**PLANNING COMMISSION SPECIAL MEETING
TUESDAY AUGUST 27, 2013 @ 6:30 PM
LIBRARY MEETING ROOM**

- a. Site Plan Review Baler Facility - Recommendation to City Council (voice vote)

To: Planning Commission
From: Planning Staff and Public Works
Date: 8/21/2013
Re: Site Plan Review ~ Baler Building Reconstruction

Baler Building Renovation - RFP

Baler Drainage Plan

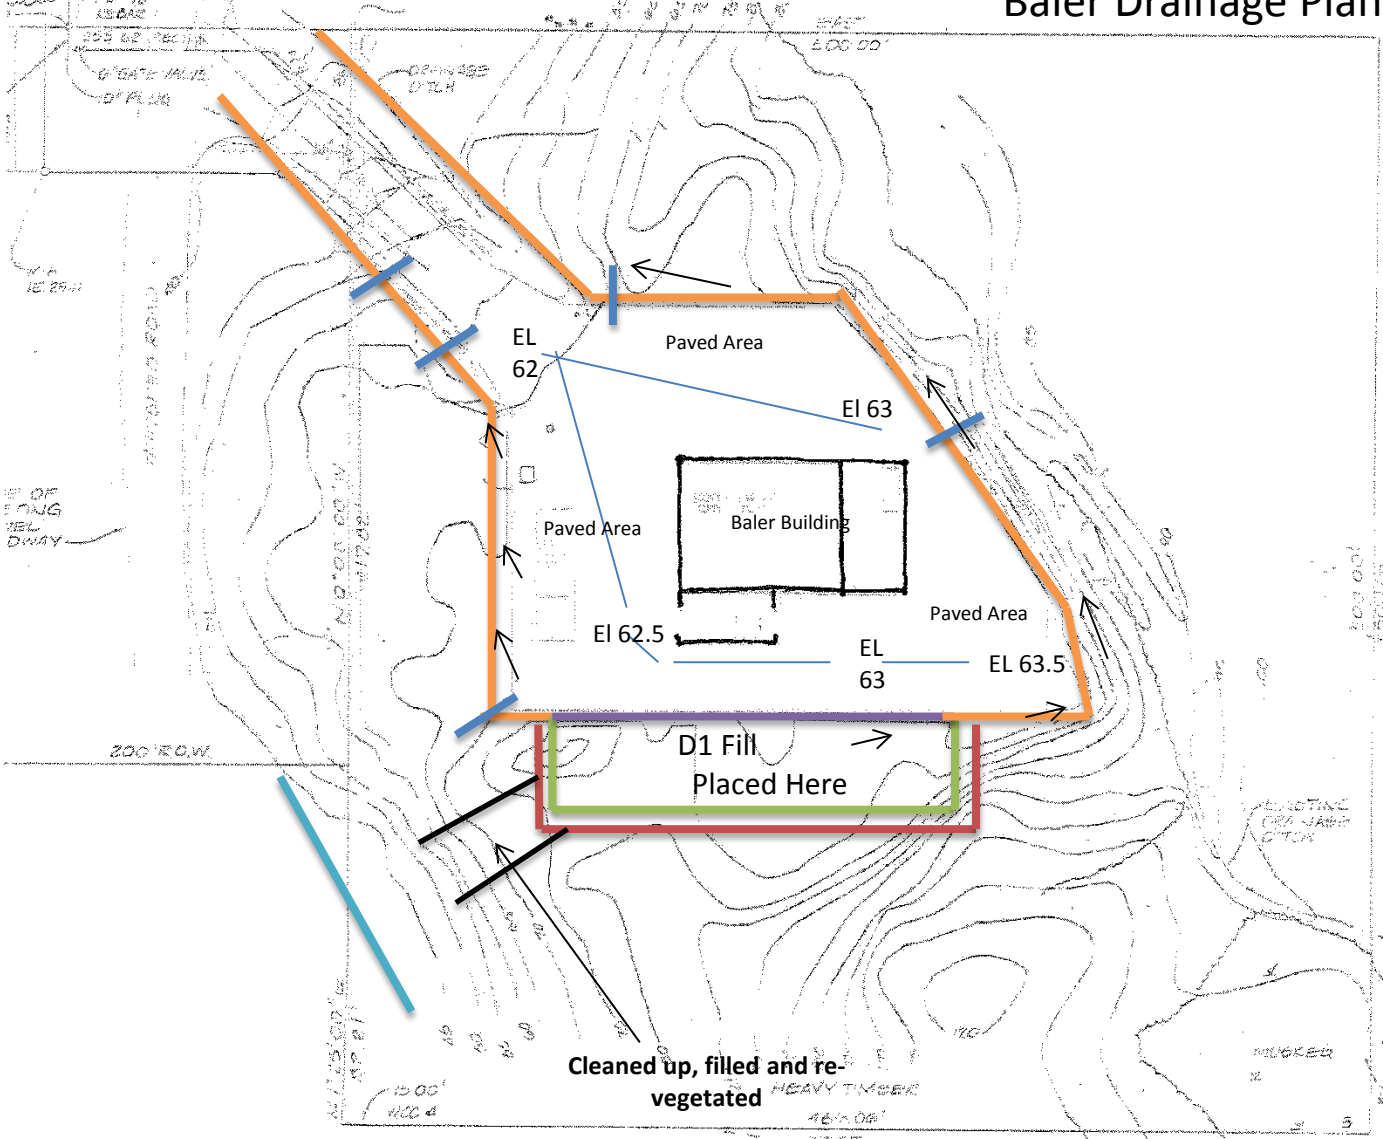
I'm writing to you in your capacity as Chair of the Planning and Zoning Commission to urge that you include a drainage plan for the baler facility in reviewing the plans to upgrade the facility at next week's special P&Z Commission meeting.

In the course of doing that work we noticed substantial problems with sediment in the sheet flow drainage coming from the baler yard. The amount of sediment in run-off from the baler site improved a little when the yard was paved, but now that it's been expanded and there are exposed soils again, there is quite a bit of sediment being discharged from that site. And the sediment -laden run-off ends up primarily in Whiskey Creek which is a catalogued fish stream that also drains to Eccles Creek, another catalogued fish stream. (I have old pictures from 2010, before the yard was paved, but not more recent ones. We can take some to illustrate the problem the next time we get a heavy rain.)

I won't be able to attend the meeting next week but I wanted to be sure that this issue is part of the discussion. Please consider how the baler site drainage can be improved, both the run-off from the hill side and the run-off from the building's roof, to "keep the clean water clean" and direct water away from the paved surface and from the exposed soils around the pavement.

As you are already aware, there is a significant amount of sediment-laden stormwater runoff flowing into Whiskey Creek from the area of the Baler property. Whiskey Creek is cataloged as important for anadromous fish and is known to support coho salmon and cutthroat trout. Whiskey Creek drains into Eccles Creek which is also cataloged as important for anadromous fish and is known to support coho and pink salmon as well as cutthroat trout. The stormwater runoff currently entering Whiskey Creek is impacting fish habitat and water quality in both streams. Fish habitat improvement projects on both streams have been completed earlier this year resulting in a net gain in available habitat for spawning and rearing salmonids. Improving water quality in Whiskey Creek is necessary to reap the full benefits of the culvert replacement and channel re-design projects.

- Repair/replace and extend the existing culvert under the Baler driveway (shared with the Blackler property).

- Install a new culvert under the Blackler driveway to catch runoff which is currently flowing down the driveway and picking up fine sediments along the way
- Dredge accumulated sediments from the east side of the road and create a catchment basin to allow for additional stormwater storage time (increase infiltration rate)
- Dredge accumulated sediments from ditch along east side of road (remove vegetative mat and replace when ditch improvements are complete)
- Repair/improve and install additional check dams as necessary along ditch lines to slow water and increase infiltration rate
- Plant grasses/sedges or other appropriate vegetation in ditches to help filter runoff prior to reaching Whiskey Creek

Summary of Drainage plan

Currently the paved area flows into a drainage ditch shown on the drainage plan and in the pictures. The muddy water referenced in Kirstin's letter is coming from two sources. The area on the map labeled where the "D1 fill will be added" is the major source and the area labeled "old snow dump" also contributes. The area where the D1 will be placed is driven upon and the muck is stirred up and the flows into the ditches, the silt fences and vegetation help to eliminate some of the silt but the cleanup and placement of D-1 will greatly reduce the amount of sediment entering the ditches. The plan to address these areas is phased and is as follows and shown in the drainage plan provided

1. Remove current Ditch in front of D1 area
2. Add D-1 to the area
3. Dig ditch on back of D1 Area
4. Clean up, fill and re-vegetate the old snow dump area
5. Vegetate any disturbed area behind where the gabions will be placed
6. Place gabions to stabilize the bank and eliminate further sediment
